Ref No 28/2012/0207
Land at Former Henllan Centre
Henllan Denbigh

PHASE 2 DEVELOPMENT.
6 No. PROPOSED DWELLINGS

ITEM NO: 4
WARD NO: Denbigh Upper / Henllan
APPLICATION NO: 28/2012/0207/ PR
PROPOSAL: Reserved matters submission for Phase 2 of development, including construction of six dwellings and an electrical substation
LOCATION: Henllan Centre Henllan Denbigh
APPLICANT: Wales And West Housing Association
CONSTRAINTS:
PUBLICITY UNDERTAKEN: Site Notice - Yes
 Press Notice - No
 Neighbour letters - Yes

Drawing title:
PROPOSED ELEVATIONS
PLOT 01 TO 03
Project No: 214
Drawing No: 3.02
Revision: D

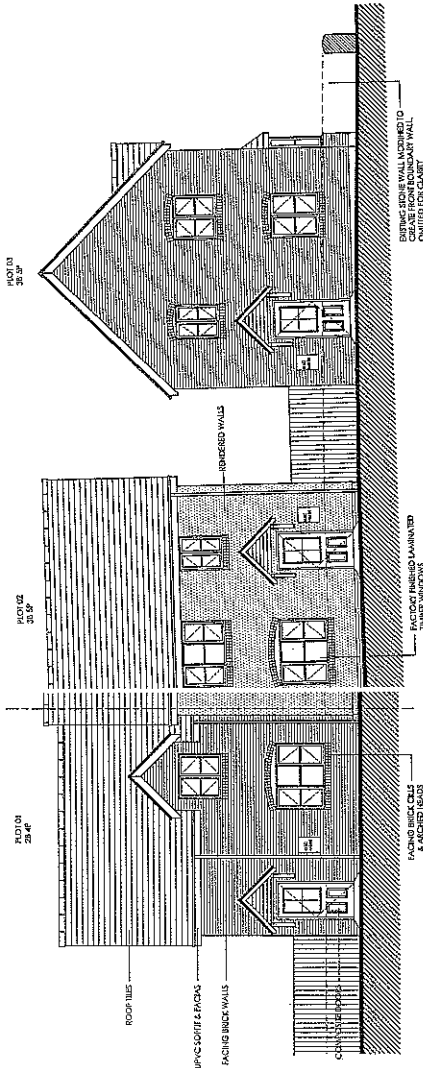
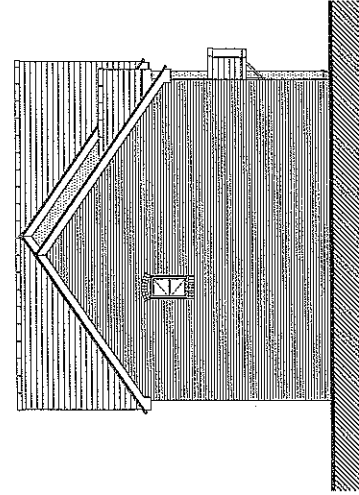
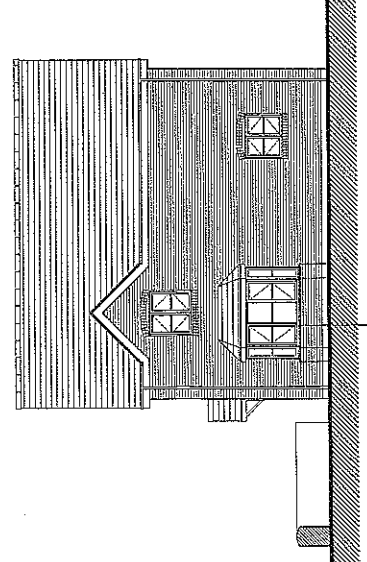
Layout and orientation of units would affect privacy of occupiers and those on adjacent site with outline permission/potential overlooking of Godre'r Garn property from plot 3 bedroom 2 window/ongoing noise and dust problems from construction works on existing site.

- Scaled from the submitted plans, the gable end bedroom window of the plot 3 dwelling would be some 24 metres from the rear wall of No. 16 Godre'r Garn, which exceeds the 21 metre window to window distance normally accepted as responsible to achieve basic privacy standards. There is also an established hedge along the boundary of No. 16 in front of this window which could be allowed to grow to provide a more effective visual screen to that property;

Drawing Title
**PROPOSED ELEVATIC
 PLOT 04 TO 06**

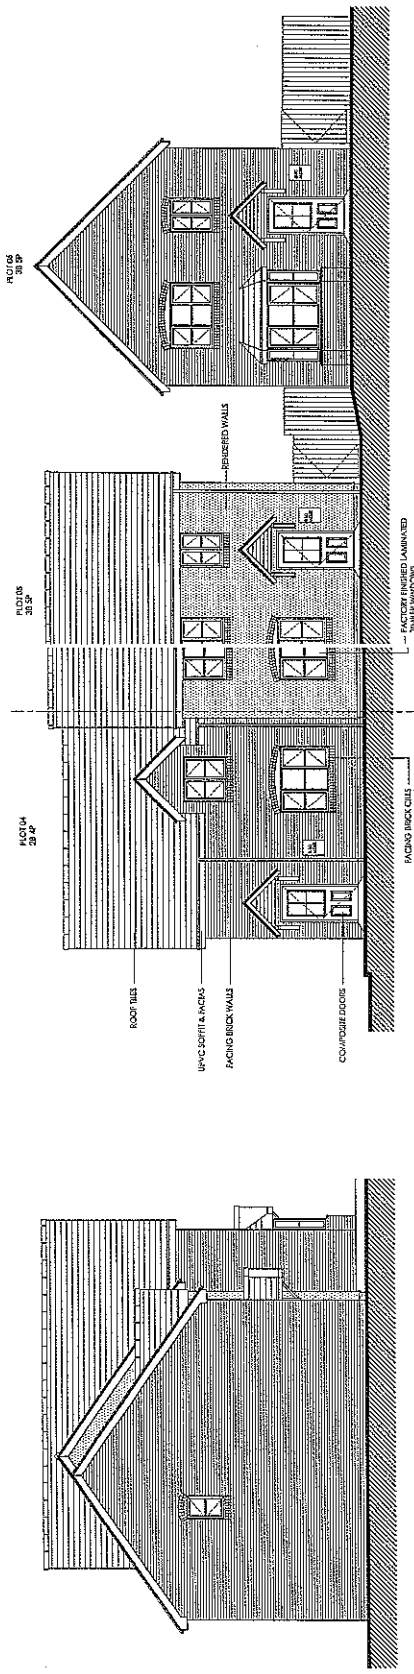
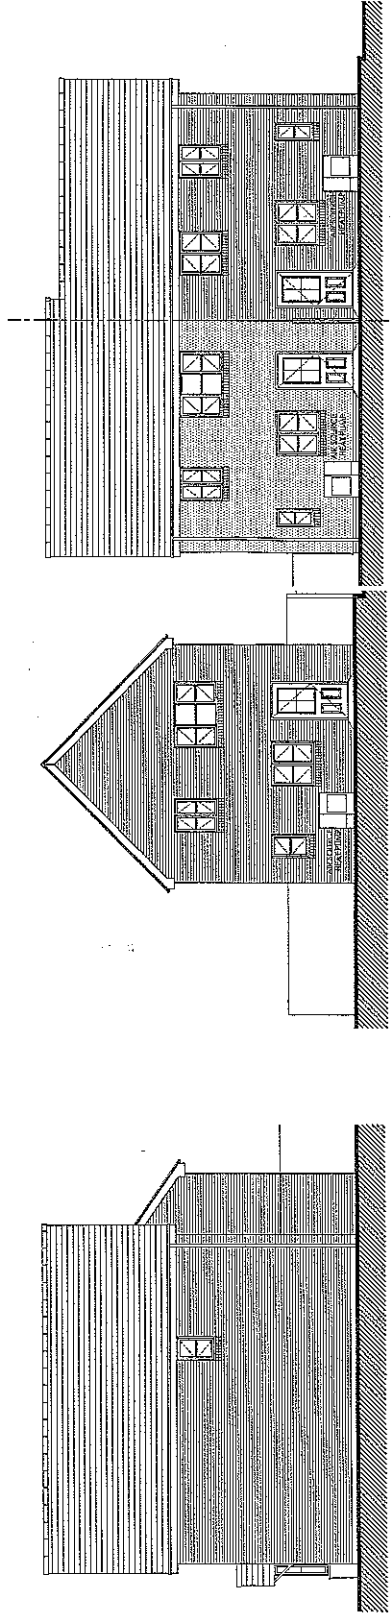
3. The reconstruction of the frontage stone wall along Garn Road shall be completed prior to the first occupation of the units hereby approved.
4. The detailing of the south east elevation of the plot 6 dwelling, and the south east boundary fencing/landscaping for this plot shall not be as shown on the submitted plans but shall be in accordance with such alternative plans as are submitted to and approved in writing by the local planning authority.

You are strongly advised to contact the Case Officer to discuss ideas for the treatment of the hedgerow/trees along the north eastern boundary of the site and the treatment of the south east boundary and garage end of the Plot 6 dwelling prior to submission of the details required by Conditions 4 and 5 of this approval. The Council consider it essential to ensure the retention of a substantial screen along the north east boundary given the site adjacent has been the subject of outline consent for development, in order to ensure adequate levels of privacy and amenity for occupiers of dwellings on both sites. The boundary of plot 6 requires landscaping treatment as it is exposed to view from the open space area.
